EGR System – Deleted on North American Specification (NAS) XK8 Vehicles

MODEL 1997 MY-ON
XK8 Range
VIN
011462-ON

ILLUSTRATION 1

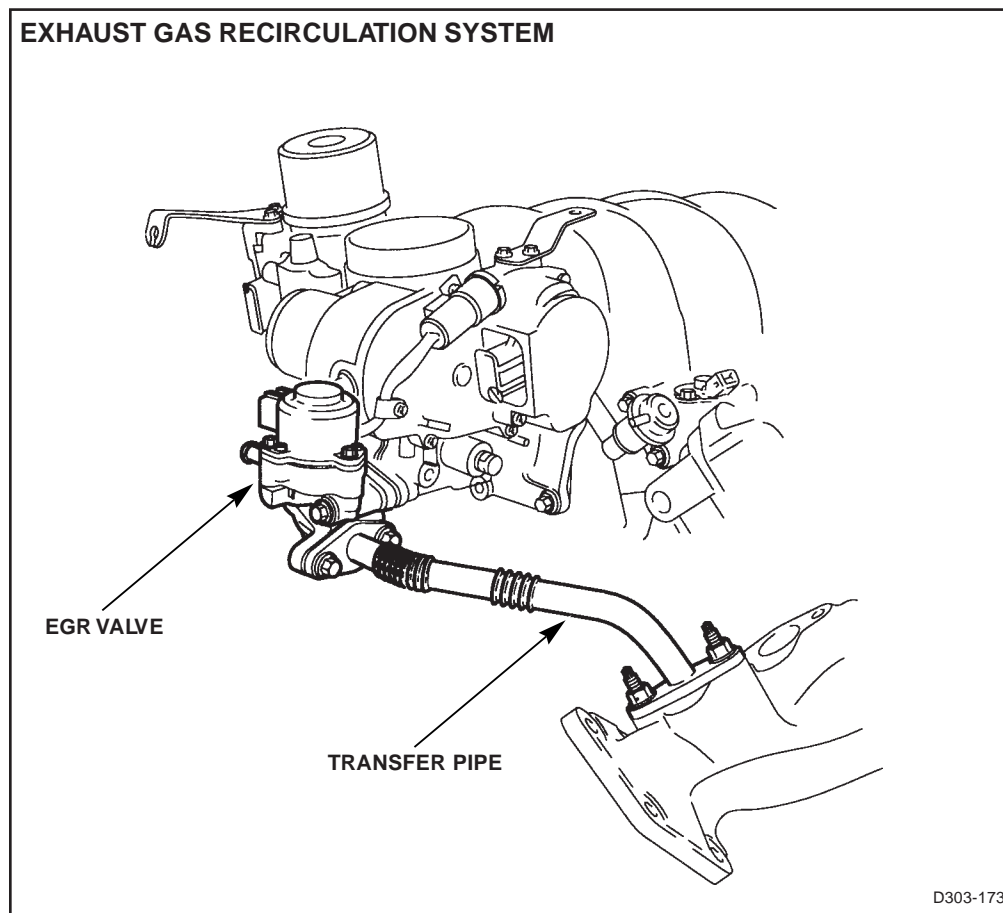
The EGR system (Illustration 1) has been deleted on NAS XK8 models beginning with VIN 011462. Vehicles with or without EGR can be equipped with the latest ECM part no. LJA 1410CA/*** which replaces LJA 1410AN/***.

*** = 010 for USA,

*** = 012 for Canada
